SERVICE BULLETIN

Document No. 159-010-00 Rev 0
Sept. 24, 2003

Model affected: Bell 204B, 205A, 205A-1, 212, 412, 412EP and Garlick UH-1H.

Subject: Cargo Hook enhanced safety.

Figure 1-1 Cargo Hook Sectional View

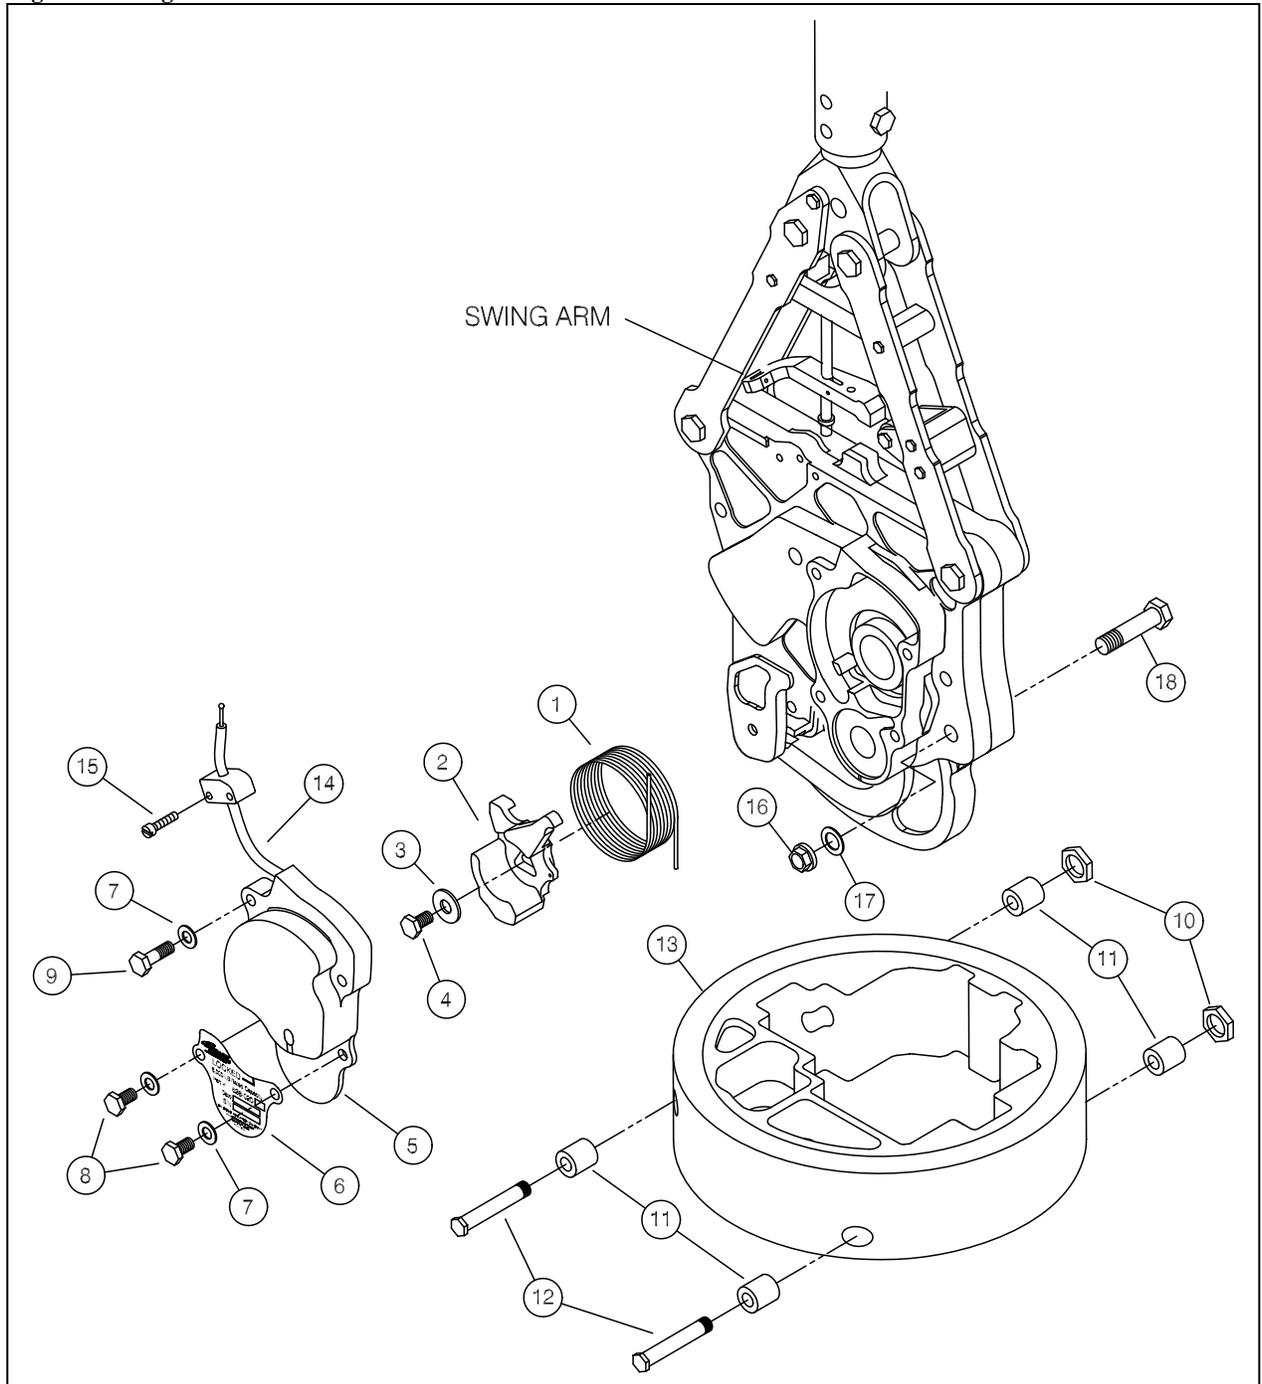
Part Two of this bulletin is elimination of the manual release lever and replacement of the cover with one that has no top facing opening.

2. Remove the Bumper Ring from the hook. To do this remove the bolts, spacers and nuts that attach the bumper (items 10, 11 and 12) and bolt, nut, and washer (items 16, 17, and 18). This will allow the bumper to slide off the bottom of the hook.

3. Disconnect manual release cable from swing arm.
4. Remove items (1-8) from the hook.
5. Place the cam hub spring (1) into the spring pocket on the outside of the hook and install the new cam hub knob (2) over it. You will need to clock the spring approximately 90 degrees by engaging it in a hole in the cam hub knob and rotating it to align with the triangular drive lug on the cam shaft. Install the cam hub knob bolt (4) and washer (3) with lockwire.

6. Remove the manual release cable (14) from the previously removed cover assy. The cable housing is screwed into the cover. To remove the cable housing rotate it counterclockwise, it should back out of the hole.

7. Screw the manual release cable assembly (14) into the new manual release cover (5).
8. With a steel stamp set or vibro-engraver transfer the serial number from the original Serial Number Plate to the new one. Stamp the new part number according to the following chart:

9. While engaging the release cable end ball shank with the cable fork on the cam hub knob (2), install the manual release cover onto the manual release side plate with the four bolts (6,9), washers (7), new serial number plate (6) and lockwire.
10. Pull the release cable and verify that the mechanism moves freely.
11. Install the two mount block screws (15) into the hook body.
12. Connect the manual release cable to the swing arm.
13. Check and adjust the rigging of the manual release cables as described in the following instructions.
